SERVICE
COIN COLLECTORS, SUBSCRIBER SET REQUIRED
220 SERIES

1.02 This section is reissued to:

Fig. 2—220, 223 (C, D, G, H) Coin Collectors with 685B Subscriber Set—Coin First, Connections

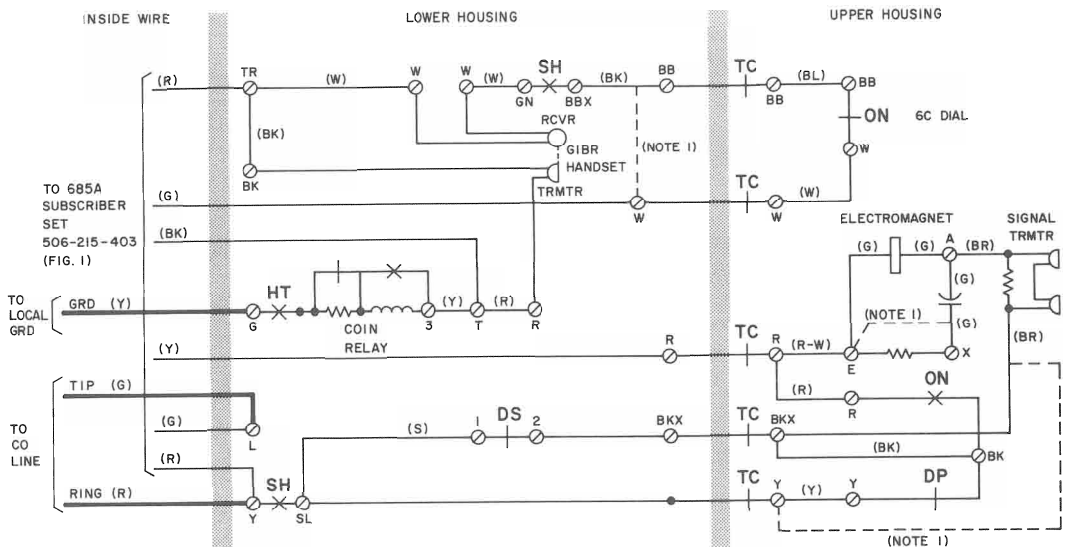
- Add a note, required when a 685B subscriber set is used with coin*collector

1. DOTTED LINES SHOW SETS WITH MANUAL CONNECTIONS
[220, 223 (C AND D)] DIAL IS REPLACED
WITH SOC APPARATUS BLANK.
2. WHEN A 6IR FILTER IS REQUIRED FOR RADIO FREQUENCY
SUPPRESSION, MOVE (Y) DIAL LEAD FROM Y UPPER HOUSING
CONTACT SPRING TO FILTER BRACKET TERM., CONNECT (Y)
FILTER LEAD TO FILTER BRACKET TERM., CONNECT (BK)
FILTER LEAD TO BK UPPER HOUSING CONTACT, AND
CONNECT (R) FILTER LEAD TO Y UPPER HOUSING CONTACT.
3. REMOVE THE (Y) STRAP BETWEEN TERMINALS 3 AND T
WHEN USED WITH THE 6BSB SUBSCRIBER SET.
